Powertex Fashions Ltd

Unit 1 DR. A. Latif-Ayesha Tower, Kamarjuri. National University Gazipur

28th February 2015

Typical column layout plan

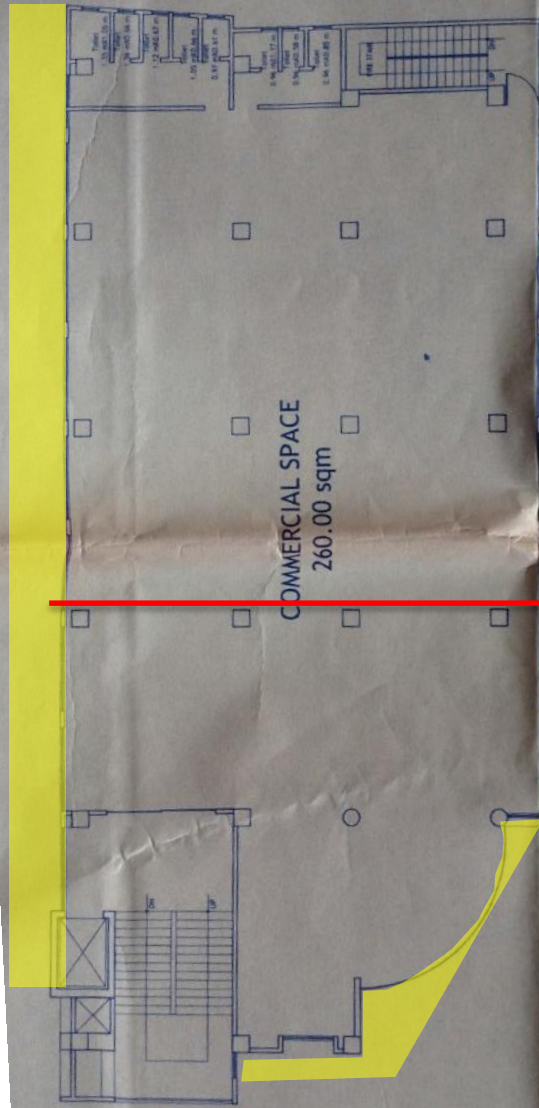
Full extent of cantilevers not shown on Permit drawing

Full extent of cantilevers not shown on Permit drawing

ITEM 1: Full extent of cantilevers not shown on Permit drawing

Item No.	Observation	Recommended Action Plan	Recommended Timeline
1	Full extent of cantilevers not shown on Permit drawing	Factory Engineer to confirm design for columns supporting cantilevered slabs.	6-months
2	Full extent of cantilevers not shown on Permit drawing	Factory Engineer to prepare floor loading plans for building as-constructed.	6-months
